Broadway-West Grand
Planning Commission, August 28, 2013
Attachment D: 6/26/13 DRC Staff
Report (with attachments)

Location:	Portion of site (Parcel B) bounded by Broadway, 23rd Street, Valley Street, and 24th Street (Parcel A is complete and occupied).
Proposal:	Amendment #3 to PUD03552 and PUDF03553 to redesign building located on Valley Street, including new site planning, decreased building height and design changes, as well as demolition of historic façade. Decreased residential density, increased commercial intensity.
Applicant:	Signature Development Group: Jamie Choy, (510)251-9270
Owner:	Signature Development Group
Planning Permits Required:	Revision to PUD, Design Review, Minor CUP for Fast Food and Auto Fee Parking, minor variance for unenclosed facility for auto-fee parking; compliance with CEQA.
General Plan:	Community Commercial
Zoning:	Community Commercial-2 Community Commercial Zone; D-BR Broadway Retail Frontage District Interim Combining Zone
Environmental Determination:	Final EIR certified on December 1, 2004 and addended in 2006 and 2008; An addendum is currently being prepared.

SUMMARY

EXISTING EAST WALL

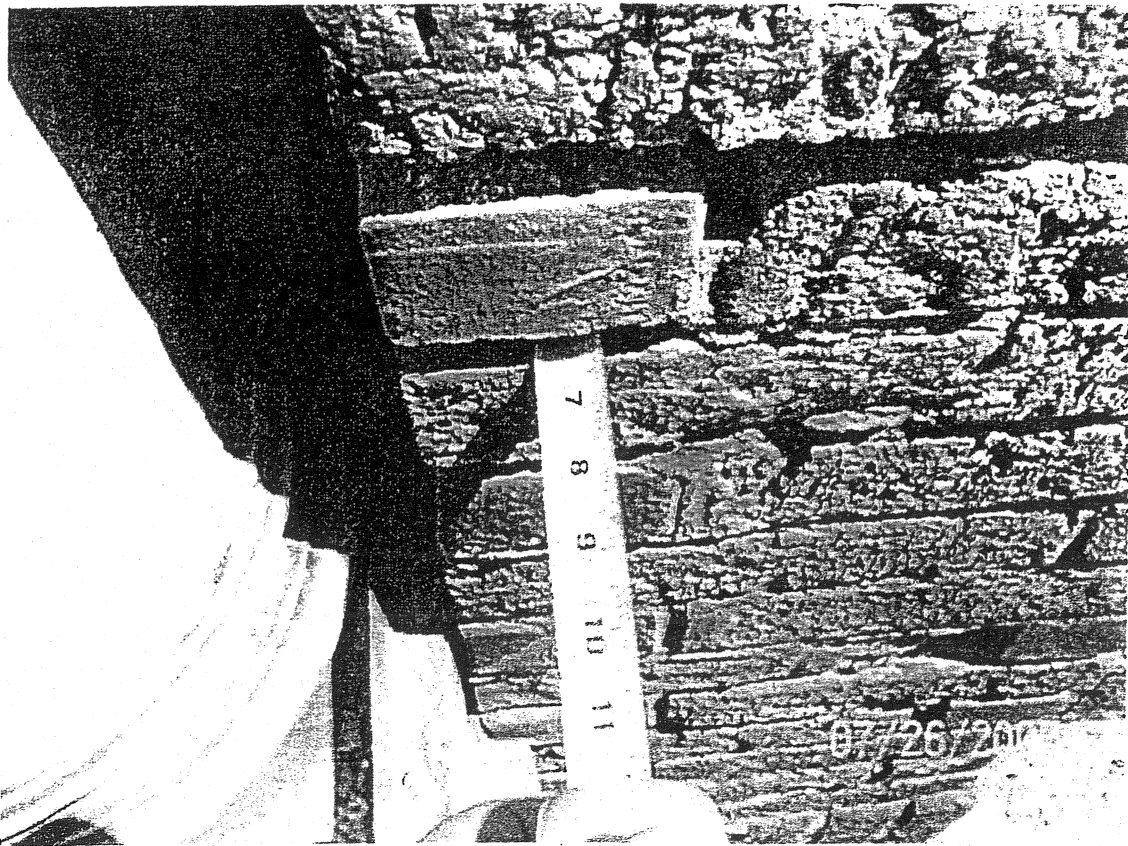
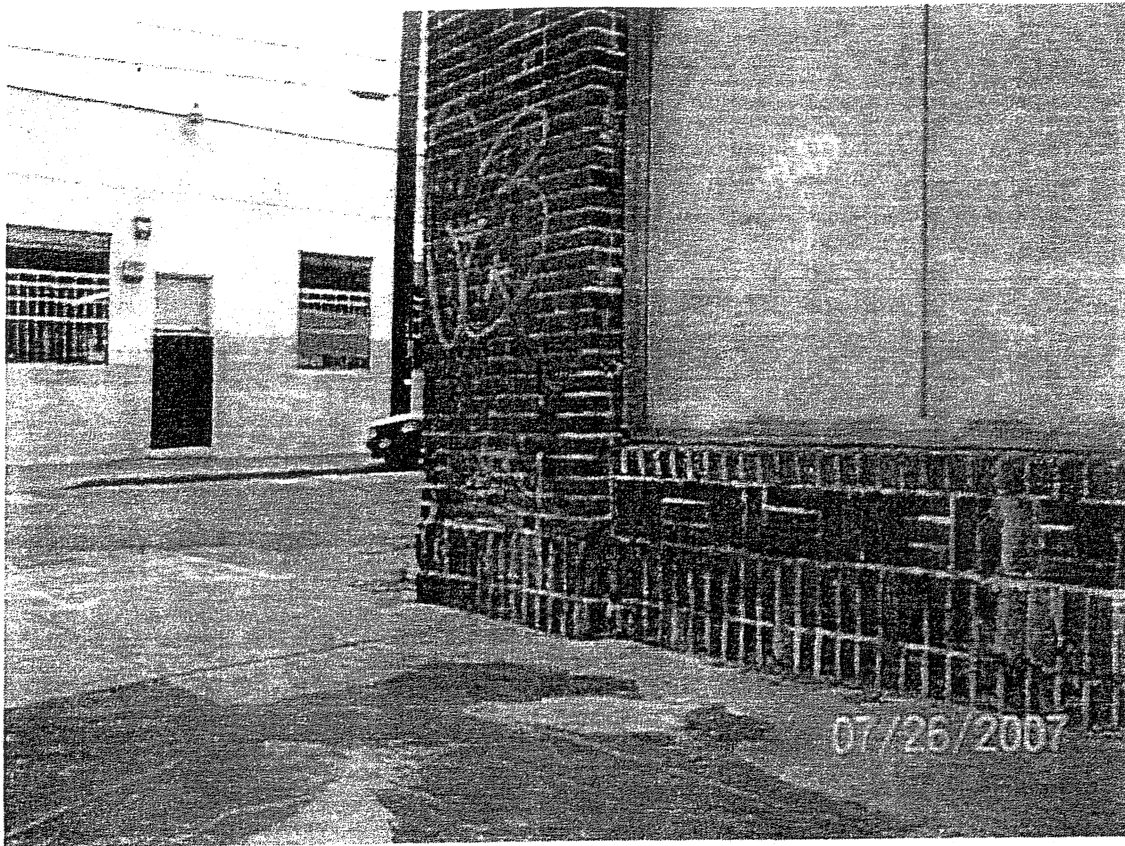
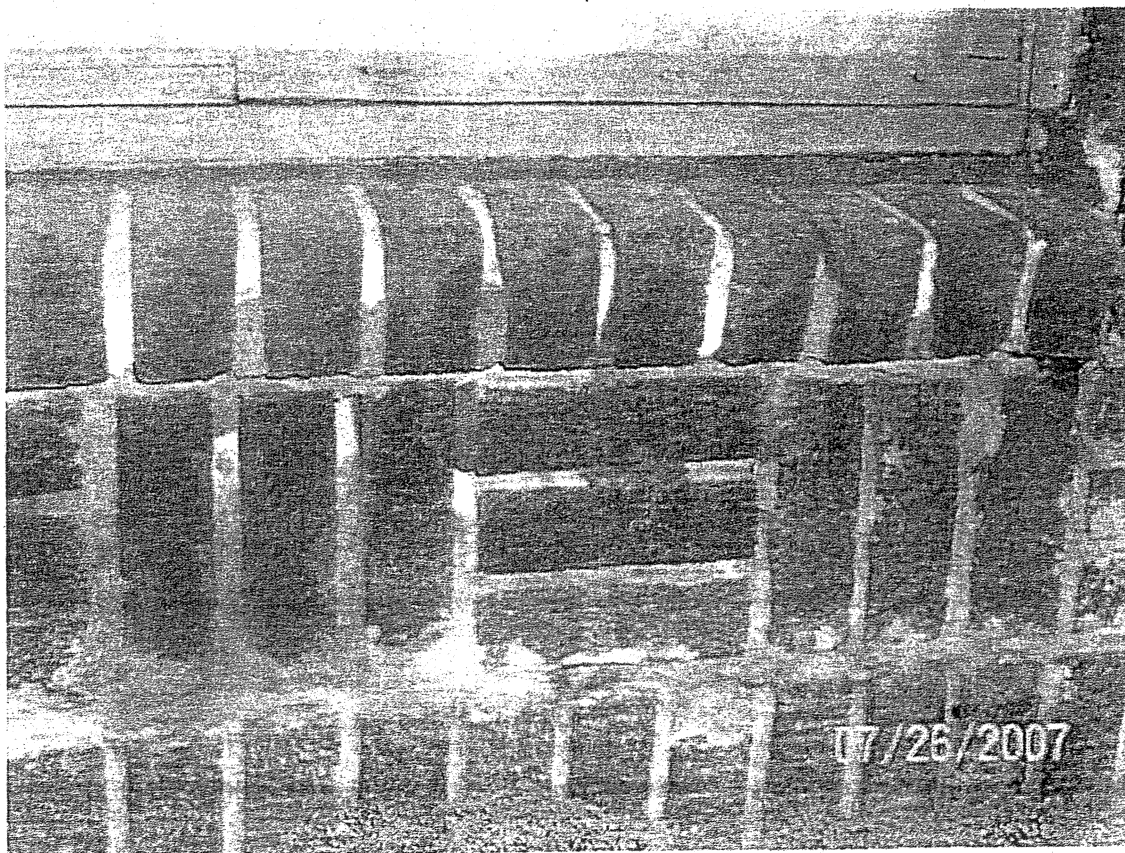
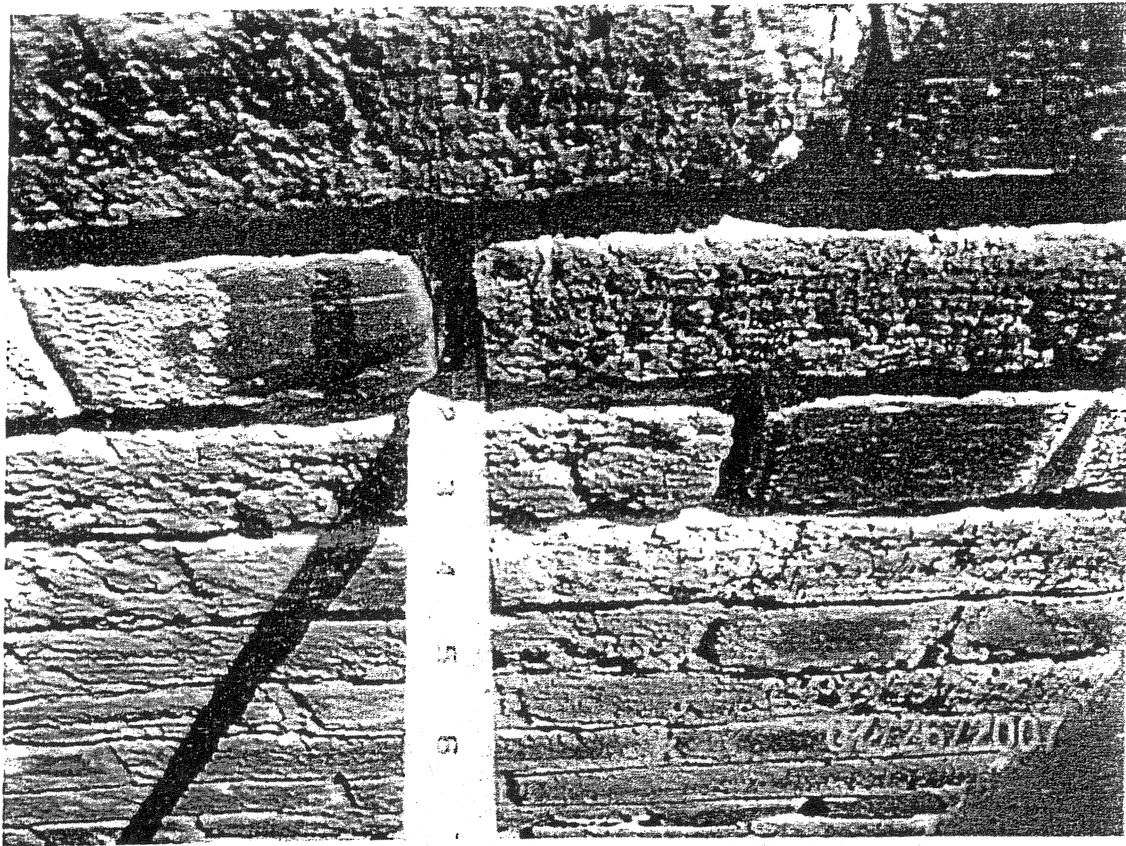
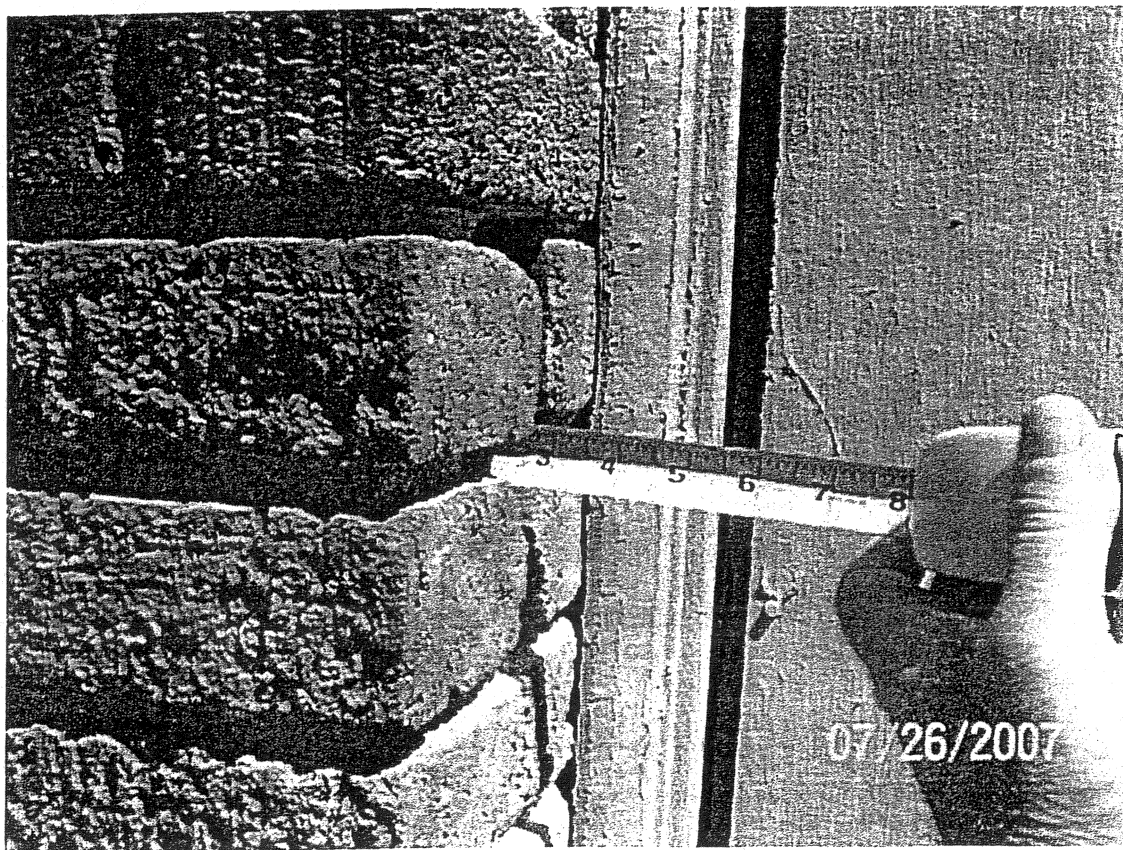
Retention of the URM facades into the new residential structure will create (a) a significant impact/change to the construction type (from Type V to I), structural system and design; and (b) substantially increase time and costs for the proposed new residential structure. The existing structure has been identified as an un-reinforced

masonry building, which has been designated by the State of California and the City of Oakland as a hazardous building type. The inherent poor performance of the UMB wall will require additional strengthening for a building that will not provide a level of seismic performance equivalent to new construction.
